#### TECHNICAL NOTE

## MODIFICATION OF THE AA-INJECTION LINE FROM END OF THE TARGET

### HALL (DUMP) TO RING SEPTUM MAGNET QDW 1

(A.72.5205/6.0)

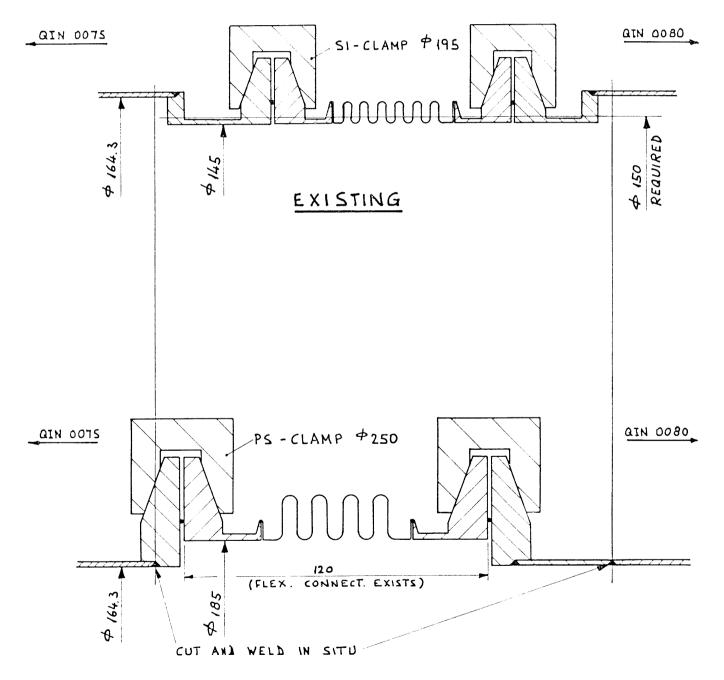
As a first stage, the septum vacuum chamber has been adapted.

Then going upstream, new vacuum chambers up to QIN 0095 were designed and made. Installation is foreseen this summer shut-down.

# PROPOSED

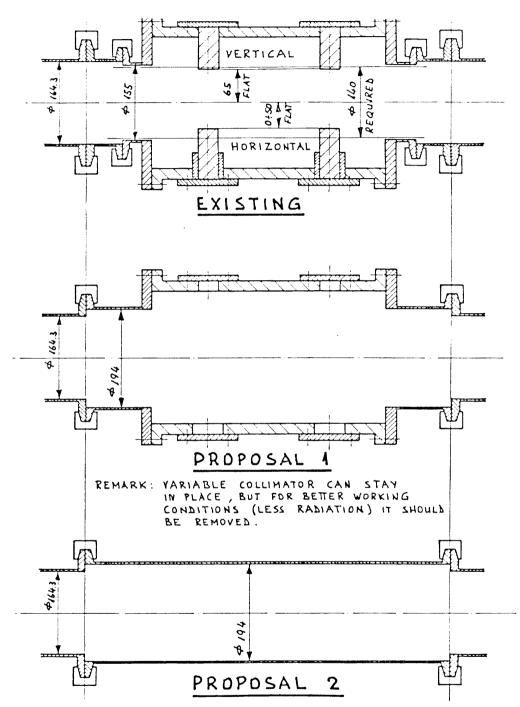
A) There is a tube in the shielding wall between the target tunnel and the AA-Ring hall surrounded by sand. Its inner diameter limits the vacuum tube components passing through it. In effect, the flanges determine the size of the bellows and its transition pieces.

REMARK: TUBES WILL BE TRAPPED AND HAVE TO BE CUT FOR REMOVAL.

REMARK: IF VARIABLE COLLIMATOR IS REMOVED,

TOP OF CONCRETE SHIELDING HAS TO BE
REMOVED.
